# Access Compliance Report

## Public Rights-of-Way

Intersection ID: 46785	Main Street: DOMINION_VILLAGE_DR	Cross Street: AUTUMN_HARVEST_LN	Location: E
ADA ID: 28D8CF3EF801	Ramp Type: BlendTrans1	Initial Pass/Fail: Fail	Overall Compliance: No
Severity Score: 33.75

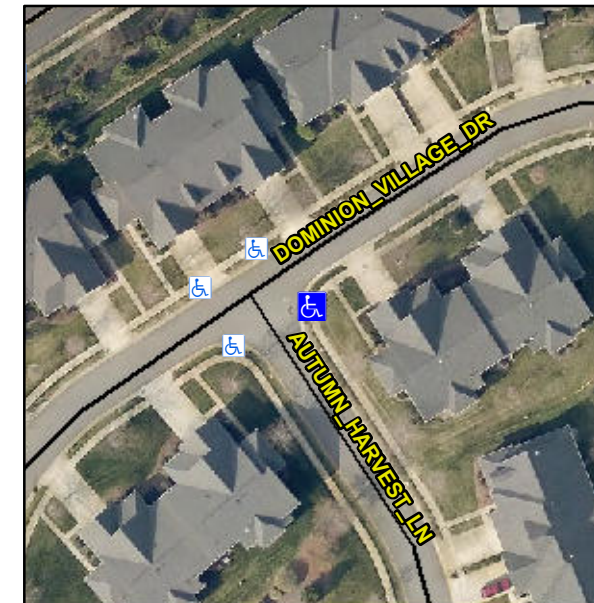
**Not Found, R304.5.1, R304.5.3**

Compliance	Description	Data	Compliance	Description	Data
N/A	Ramp Length (in)	50.0	Yes	BlendTrans Slope (%)	3.9
No	Ramp Width (in)	47.0	No	BlendTrans XSlope (%)	7.1
N/A	Flare Type LT	N/A	N/A	Flare Type RT	N/A
N/A	Flare Slope LT (%)	N/A	N/A	Flare Slope RT (%)	N/A
N/A	Flare Traversable LT?	N/A	N/A	Flare Traversable RT?	N/A
N/A	Landing Length (in)	N/A	N/A	DWS Provided?	N/A
N/A	Landing Width (in)	N/A	N/A	DWS Contrast?	N/A
N/A	Landing Slope (%)	N/A	N/A	DWS Length (in)	N/A
N/A	Landing X Slope (%)	N/A	N/A	DWS Full Width?	N/A
N/A	Landing Curb? (Y/N)	N/A	N/A	DWS Offset (in)	N/A
N/A	Shared Landing?	N/A			
N/A	Gutter Ponding?	N/A	N/A	Gutter Slope (%)	N/A
N/A	Gutter Lip Ht (in)	N/A	N/A	Gutter X Slope (%)	N/A
N/A	Painted X Walk1?	No	N/A	Painted X Walk2?	No
	X Walk 1 Direction	To NW		X Walk 2 Direction	To SW
	X Walk 1 Width (in)	N/A		X Walk 2 Width (in)	N/A
	X Walk 1 Slope (%)	4.4		X Walk 2 Slope (%)	2.2
	X Walk 1 X Slope (%)	1.6		X Walk 2 X Slope (%)	3.0

N/A	Ramp inside XWalk1?	N/A	N/A	Ramp inside XWalk2?	N/A
	Road Slope (%)	5.6		Clear Space?	N/A
	Road X Slope (%)	3.3	N/A	Clear Space to XWalk (in)	N/A
N/A	Any Obstructions?	N/A	N/A	Storm Grate/Utility Hazard?	N/A
	Obstruction Type			Storm Grate/Utility Type	
		N/A			N/A
			Yes	Surface Condition? (G/P)	Good
			No	Curb Slope (%)	11.8

**Remove & Replace Curb Ramp With Two New Directional Ramps or Equivalent.**
